Report No:	REP11-09-03
File No:	RM100632, RM100633
Report Date:	8 September 2011
Decision Required

Report to: Environment & Planning Subcommittee
Meeting Date: 19 September 2011
Subject: CBH Ltd
Report Author: Pauline Webby, Consent Planner - Subdivision

Subdivision (RM100632)

Land Use Consent (RM100633)

Job No. 0593 Scale 1:4000 @ A2
 Client: CBH Ltd
 Sheet 2 of 2
 Plan A" RM100632

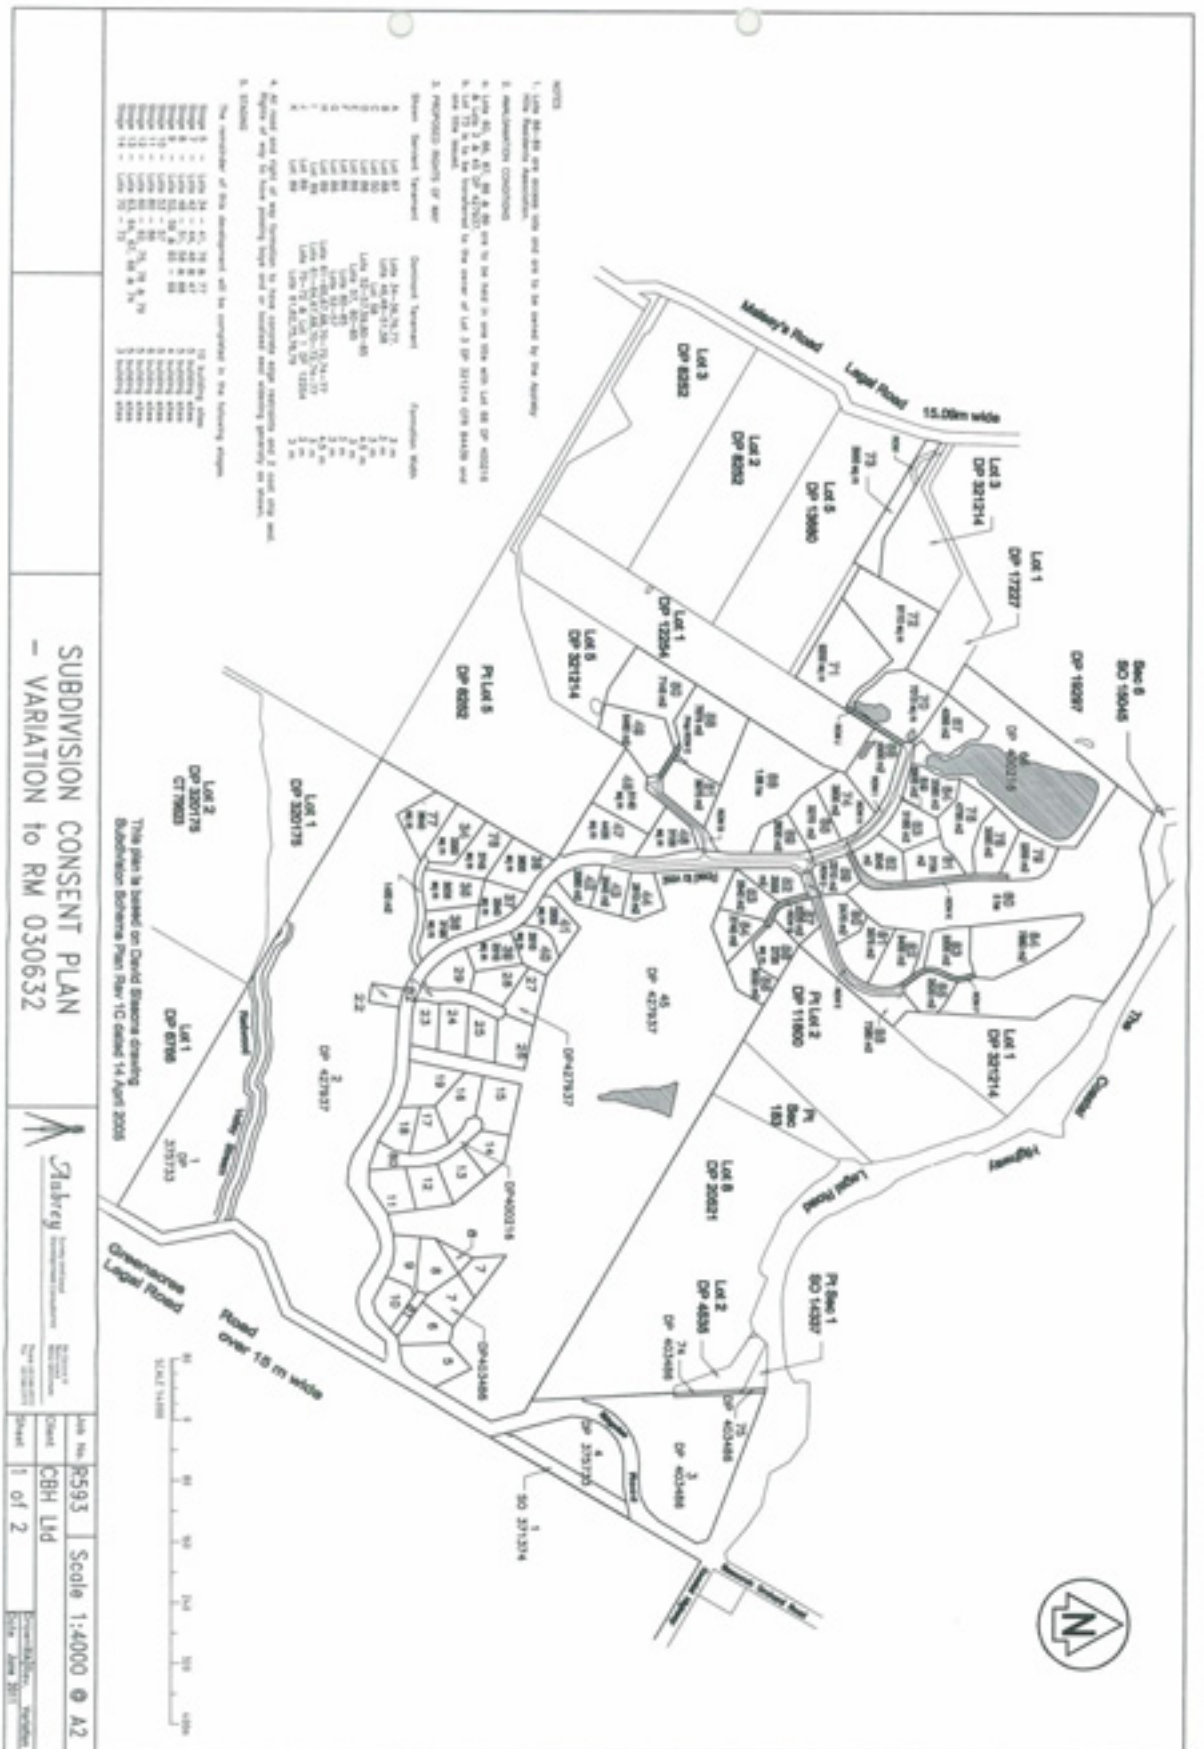
1. The subdivision and development shall be carried out in accordance with the revised application plan by Aubrey Survey & Land Development Consultancy Job No. R593 dated September 2010 and attached to this consent as Plan A.

Appendix A Sheet 1

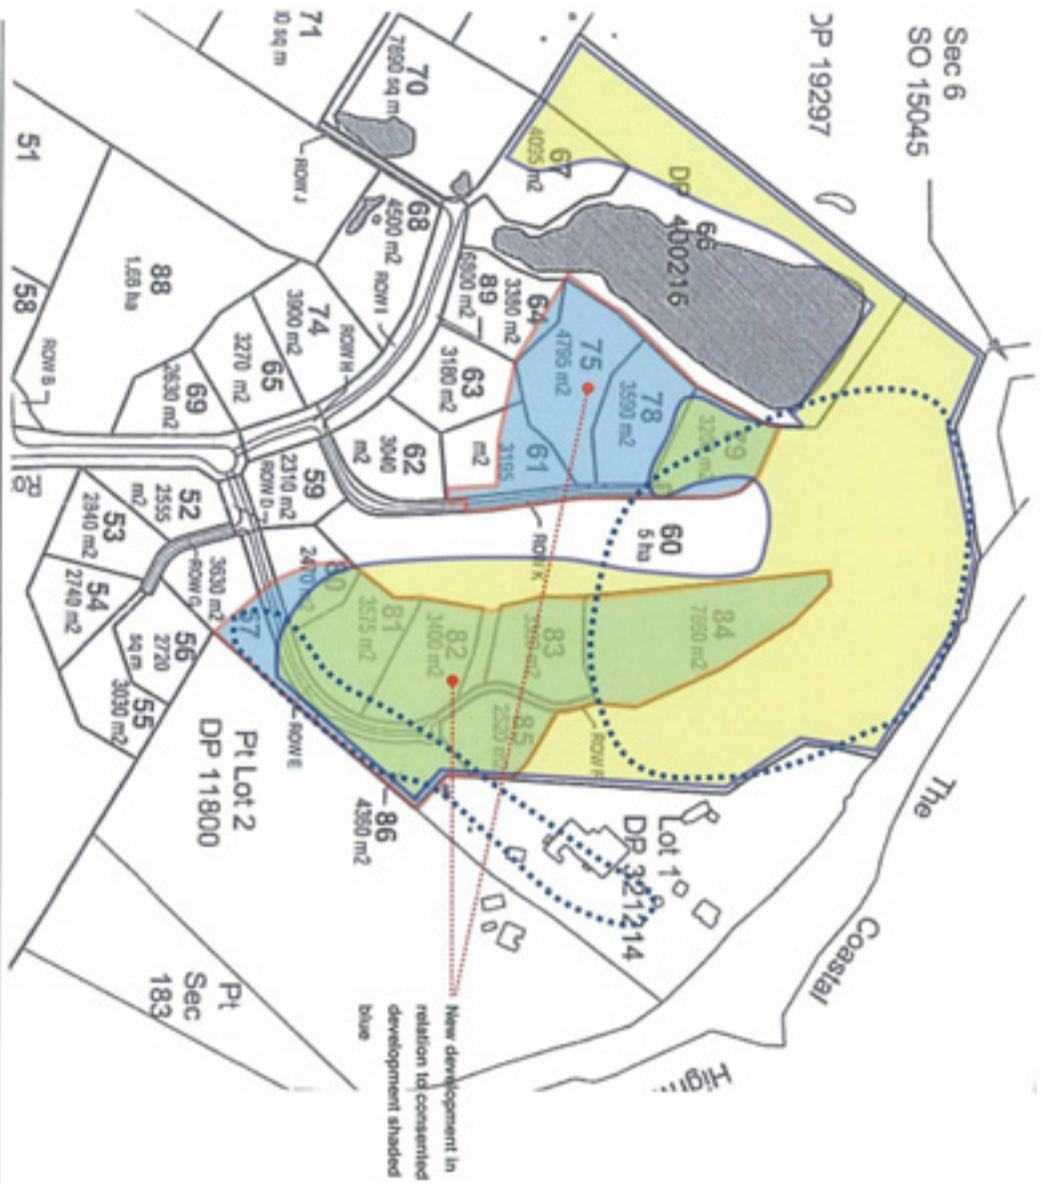
10. I have mapped and attached within Appendix A Sheet 1:
- The general areas of new housing in relation to the consented housing clusters;
 - The area mapped by Mr Sissons' as high visibility; and

- The two particular areas mapped as constraints by Mr Langbridge.
11. I will return to the drawing on Sheet 1 later in my report.

24. The rationale for proposed development of Lot 79, 80, 81, 82, 83, 84 and 85 appears to be based on estimated effects illustrated in Figure 2, which may inadvertently provide an inaccurate view of consented development effects in relation to consented Lots 60, 61 and 59. That situation is entrenched by the lack of consideration of the mitigating effect of a foreground spur identified by Mr Sisson and evident on the Application Site.

25. A further complication is the down grading of a mapped high visibility area affecting the visual amenity from SH60 and consideration of the effect that orchard removal has had on the Sisson's assessment. Generally for those reasons but also related to lack of detail regarding structural planting development of Lot 79, 80, 81, 82, 83, 84 and 85 is not supported.
